ADDENDUM #1
BL065-26, Gwinnett County Centerville Senior Center Expansion

QUESTIONS & ANSWERS:

FP200

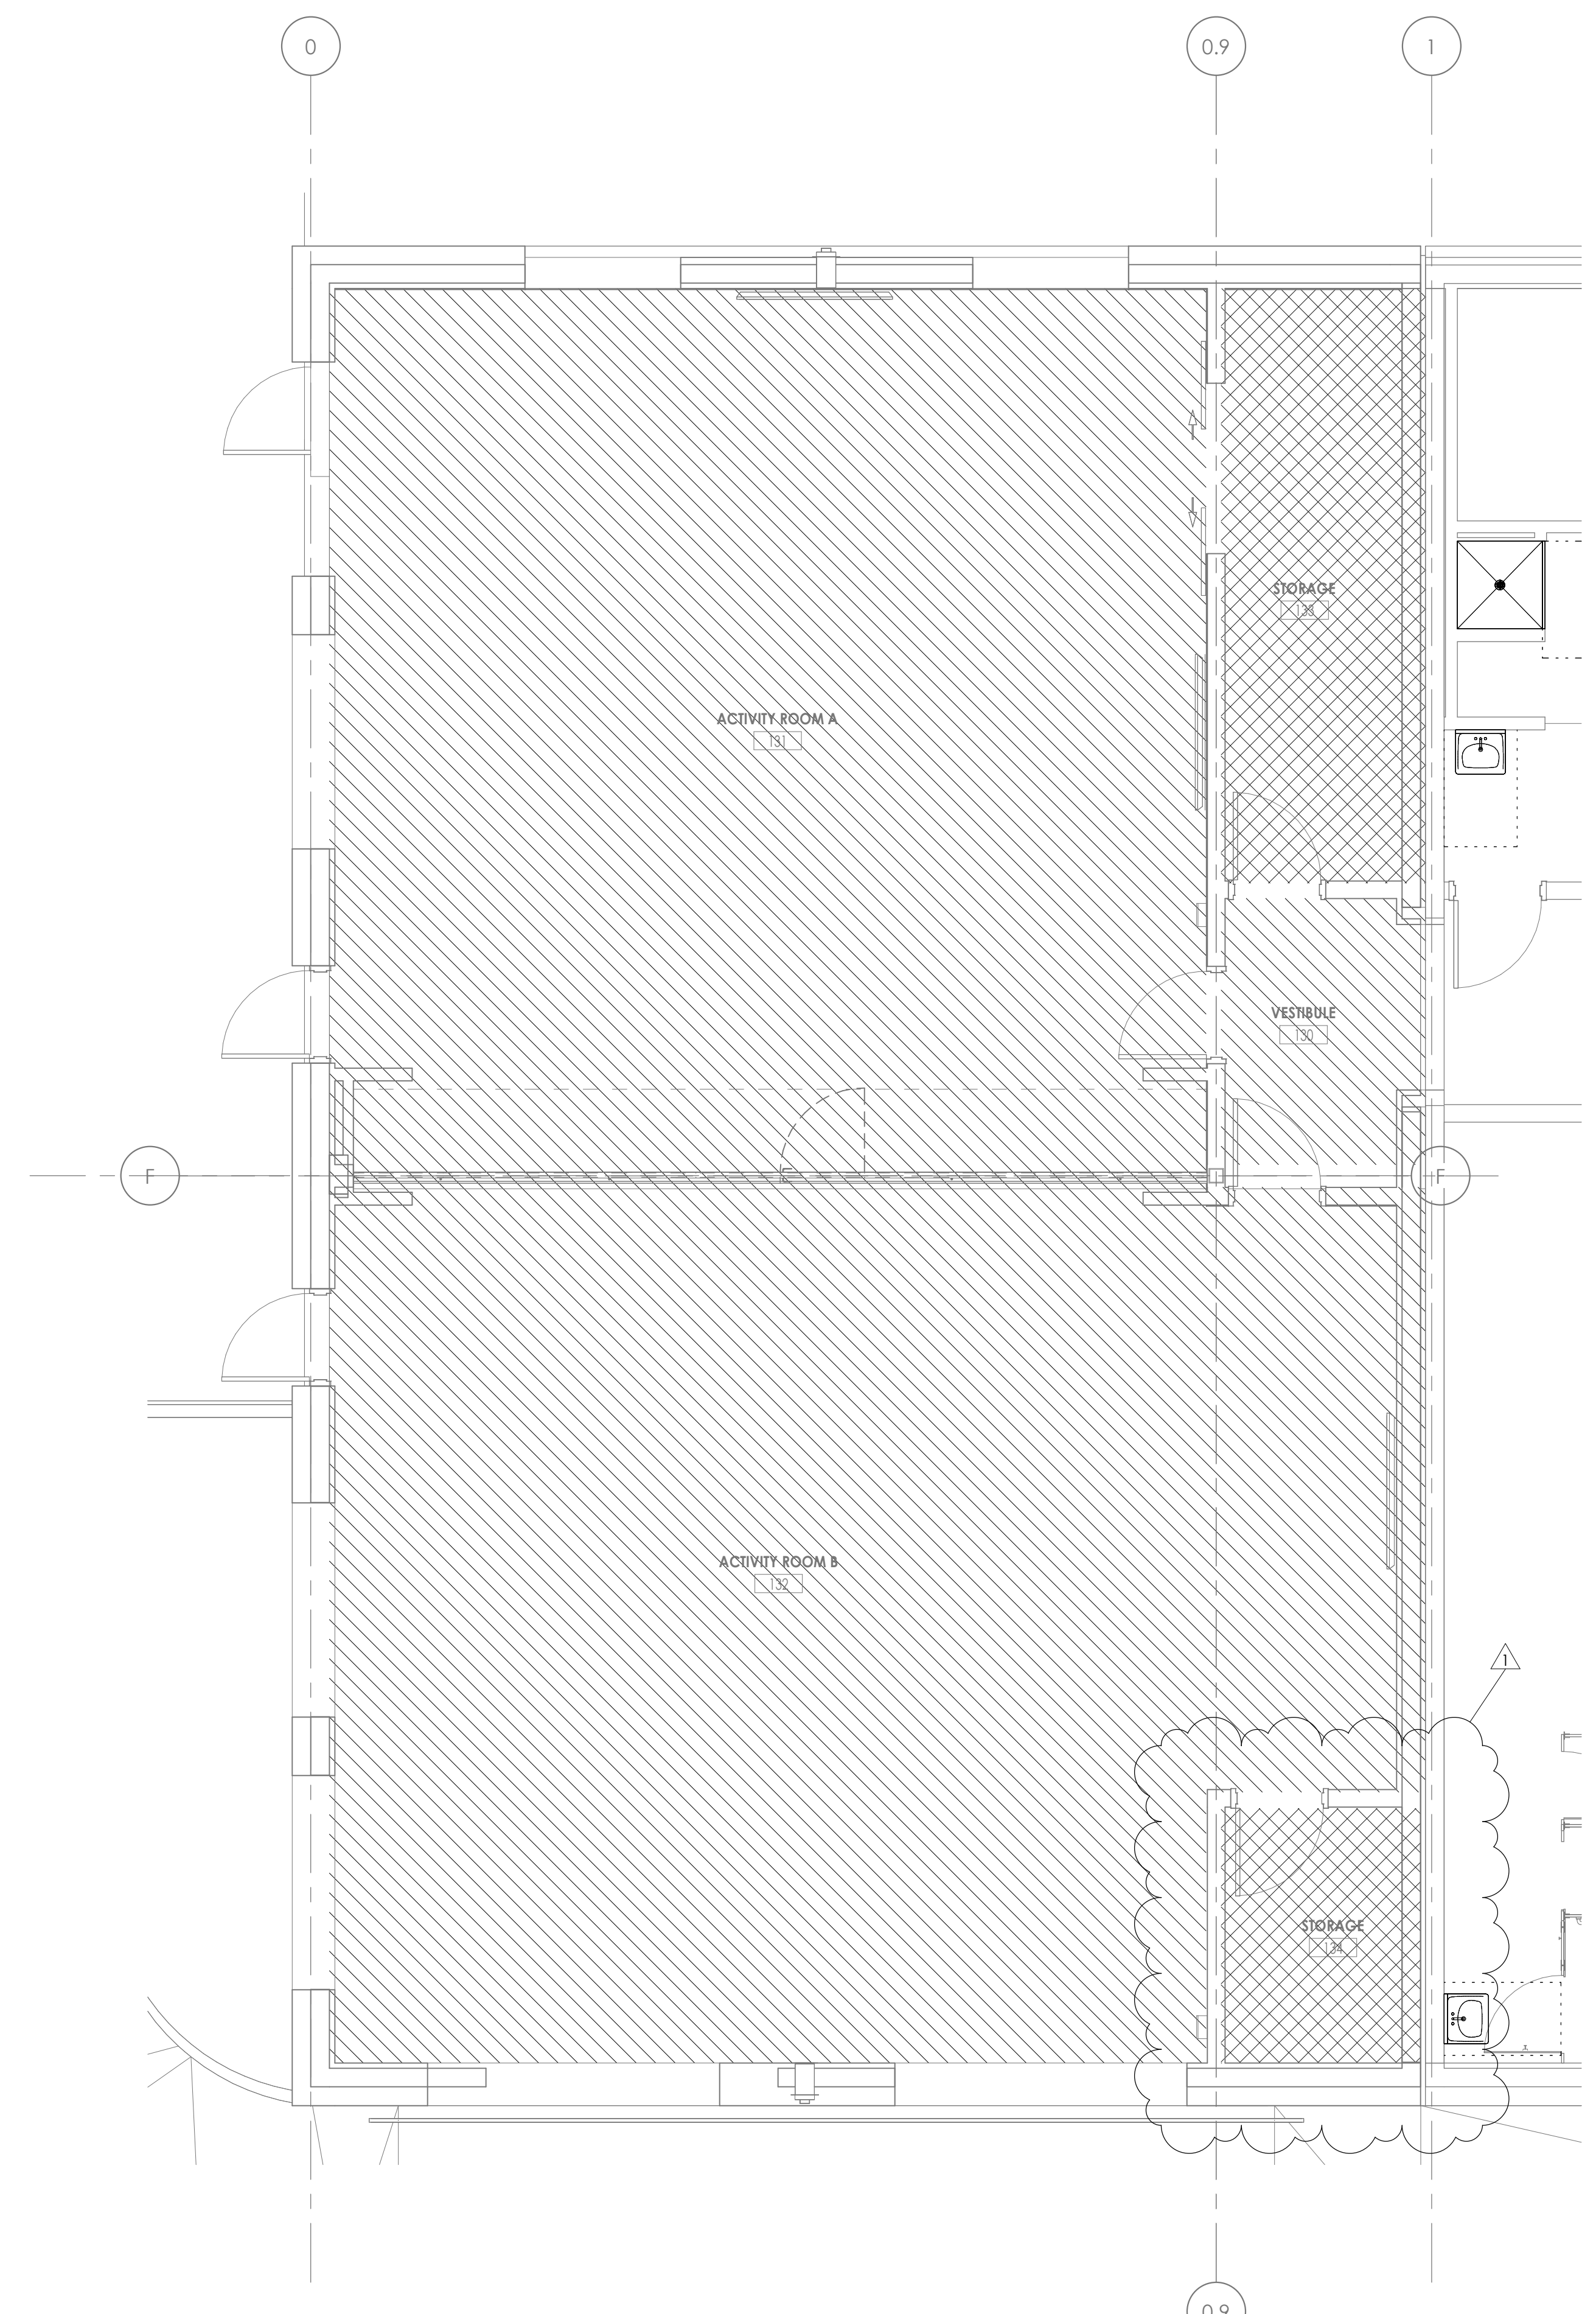
- Q25. Section 01 00 00 lists FP200 "First Floor Fire Protection New Work Plan" but notes it is excluded from the permit set, while A601 refers to "P" or "FP" series drawings for sprinkler head locations and Section 21 13 00 requires sprinkler coverage. Please provide FP200 or clarify.**

- A25. FP200 was removed from the building permit set at the request of the Fire Marshal – as the Fire Protection scope is a delegated design and full shop drawings should be provided by the Awarded GC's FP contractor. The FP200 sheet is provided for reference with this Addendum.

**CENTERVILLE SENIOR CENTER
 PROPOSED SITE LOGISTICS PLAN
 6/24/2026**

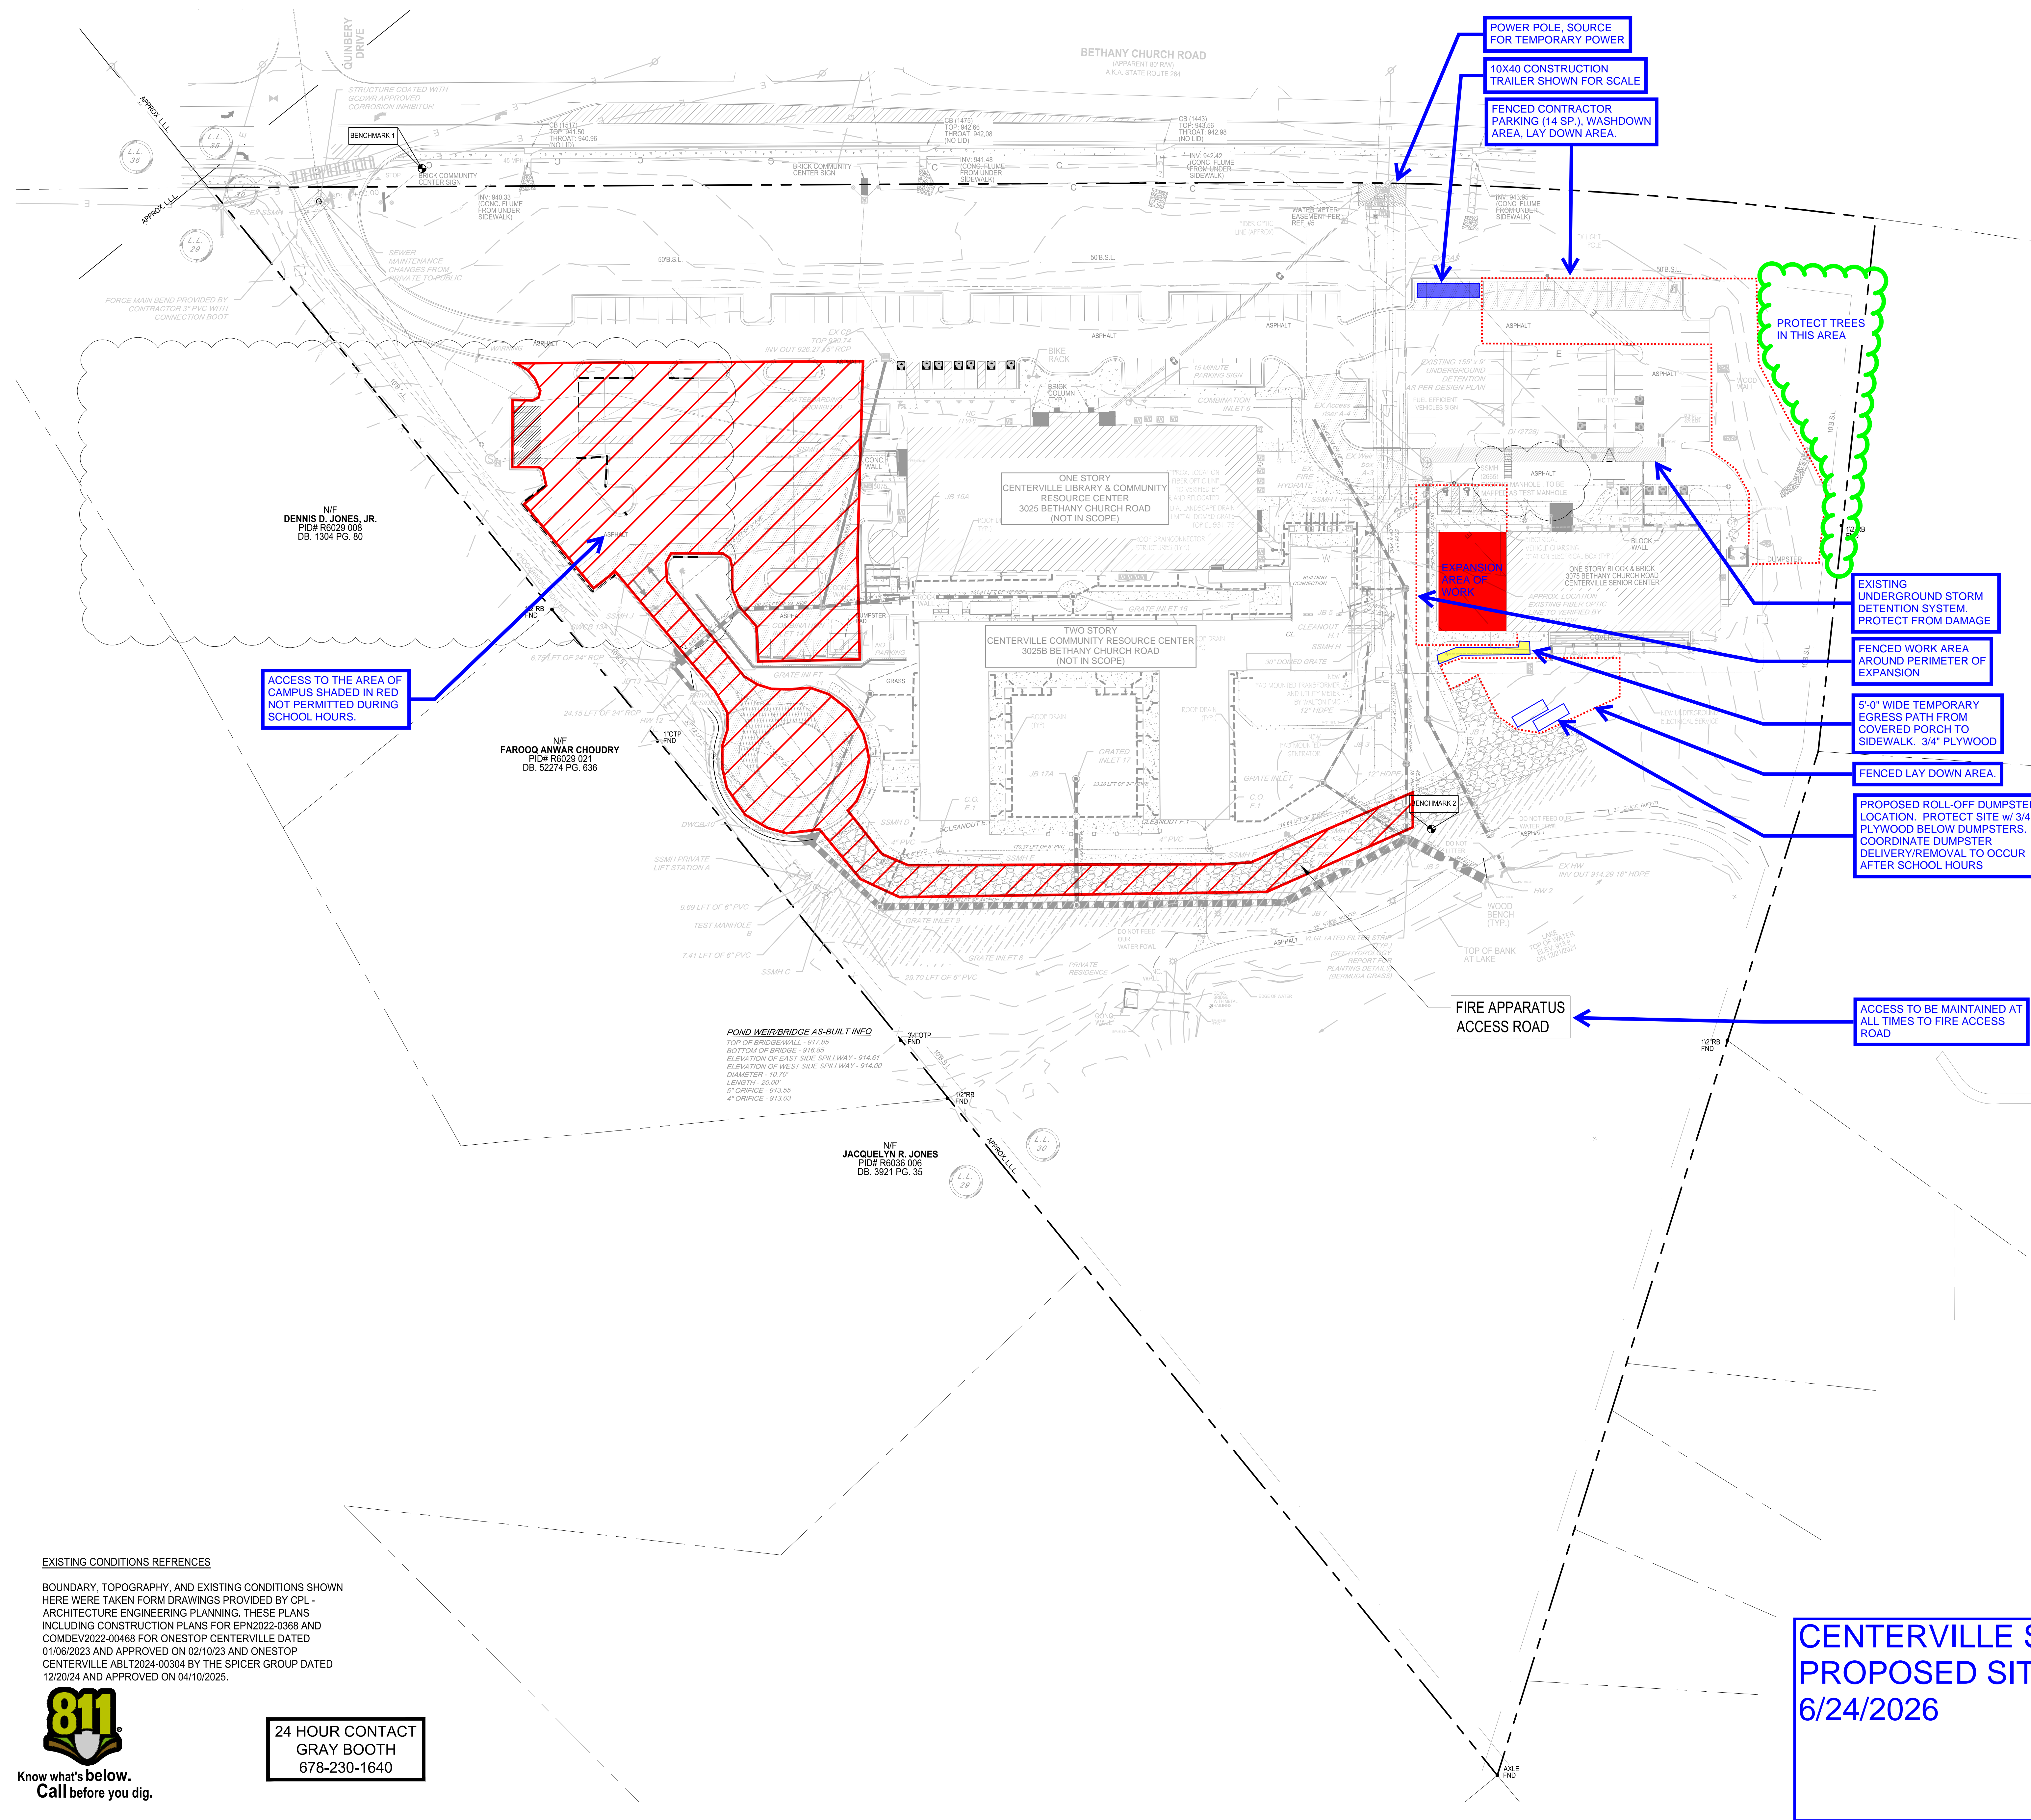
1. Pre-Bid Conference Sign In Sheet 6.10.26
2. Drawing FP200 First Floor Fire Protection New Work Plan, dated 03/18/2026.
3. Proposed Site Logistics Plan - Addendum 01_20260624 (adjusted for GCPS occupying lower level of the Community Resource Center starting in August '26).

4. Revised Bid Form (Change made to Allowance #4, increasing Sod quantity to 10,000sf to reflect changes to staging areas on the Proposed Site Logistics Plan.)
